PLANNING COMMISSION  
DATE: 3/9/15  
AGENDA ITEM: 5A – PUBLIC HEARING  
CASE # 2015-05

ITEM: Boulder Ponds – Final Plat, Final PUD Plan and Zoning Map Amendment

SUBMITTED BY: Nick Johnson, City Planner

Date: 01/30/15 Sheet: LS9 OF 10

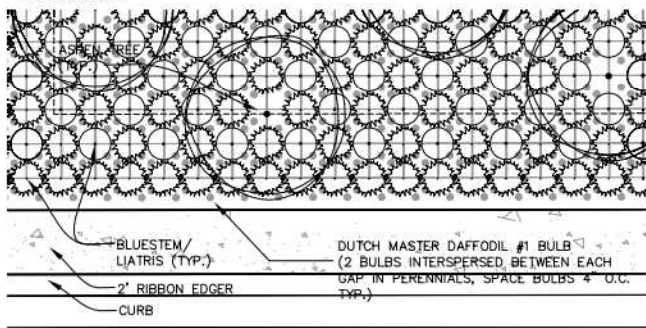
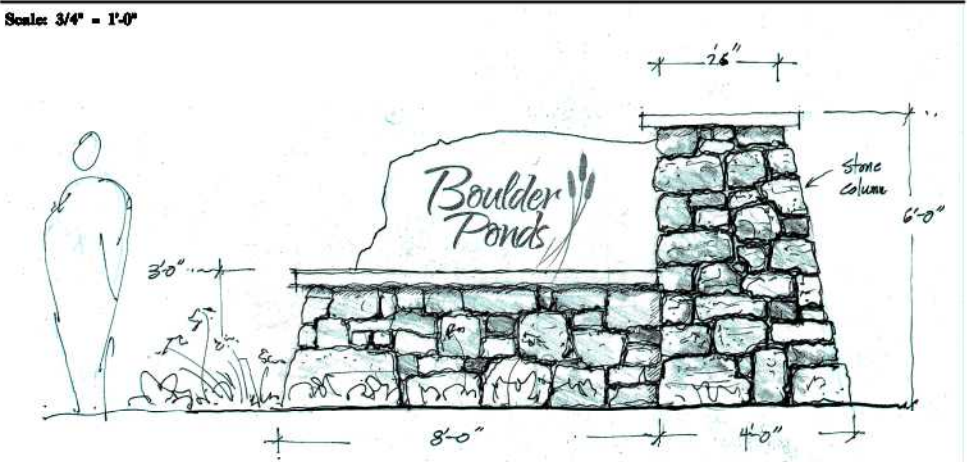
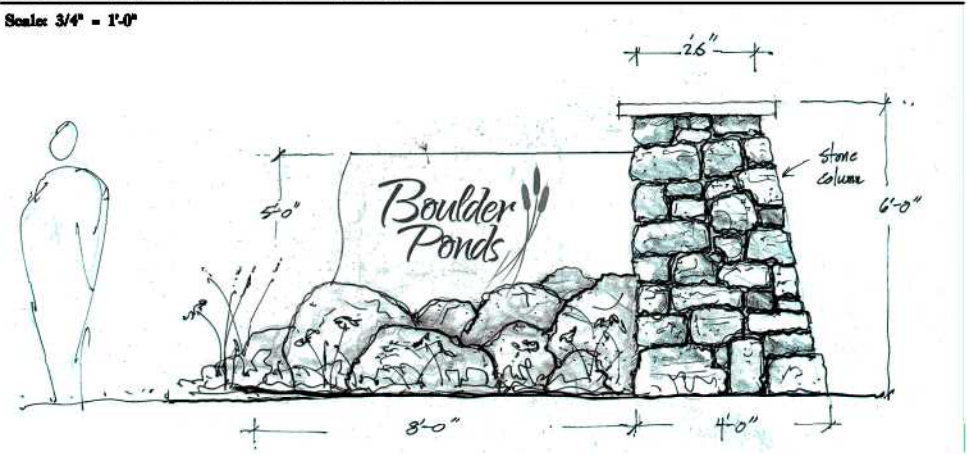
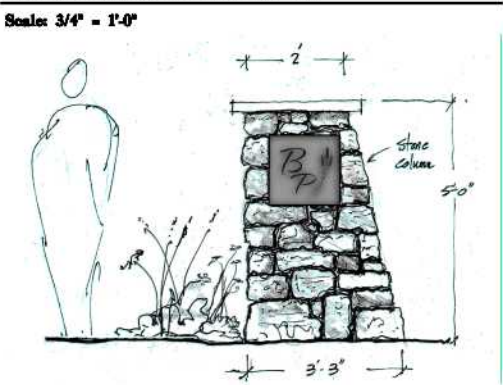
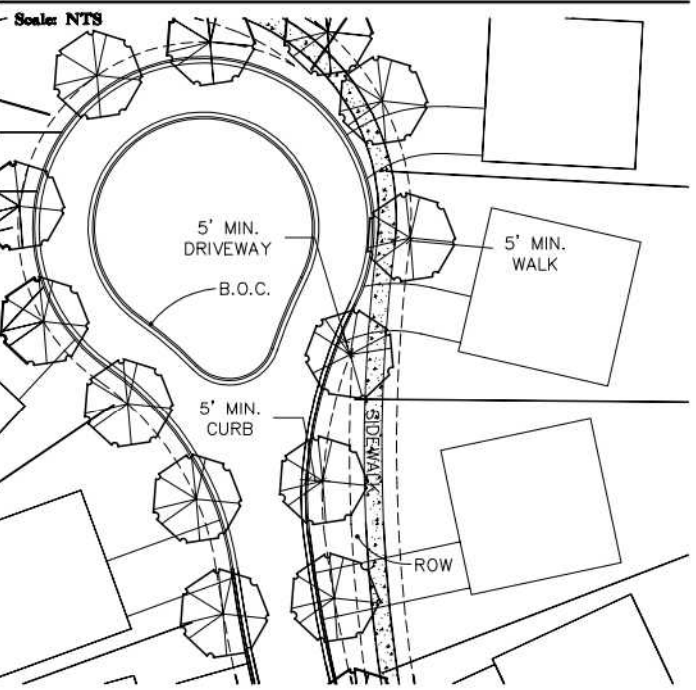
4. The quality of the site amenities proposed on Sheet LS9 of 10 are not consistent with the higher quality homes and planting areas suggested within this development. We would challenge your team to specify site amenities of higher quality design and materials that will enhance those spaces and bring it the same level of thoughtfulness suggested everywhere else.
